51 & 55 Hawkesville Road, Woolwich

DPC & OPA/ZBA Applications

1st Submission Comments & Responses

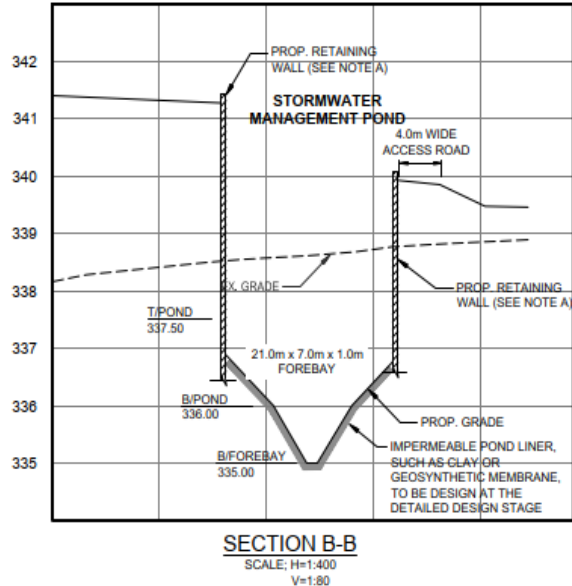
Phase One Environment Site Assessment	
		Section 1.0/2.0	
		Section 1.0 of the Phase I ESA notes that the work was completed for due diligence purposes. Section 2.0 of the report indicates that the scope of Phase I ESA was generally in accordance with requirements of CSA Standard Z768-01 (R2022). The consultant should provide information with respect to the suitability of using CSA standards as opposed to completing the Phase I ESA and overall site requirements in consideration of O.Reg. 153/04 – Records of Site Condition.	Premier was retained by Polocorp Inc. to complete a Phase I ESA at the subject property for due diligence purposes. The industry standard for completing Phase I ESAs for due diligence purposes is (CAN/CSA) Standard Z768-01 (R2022). If future plans for the property include development to a more sensitive land use, an O. Reg 153/04 Phase One ESA at minimum would be required to support filing for a Record of Site Condition (RSC).
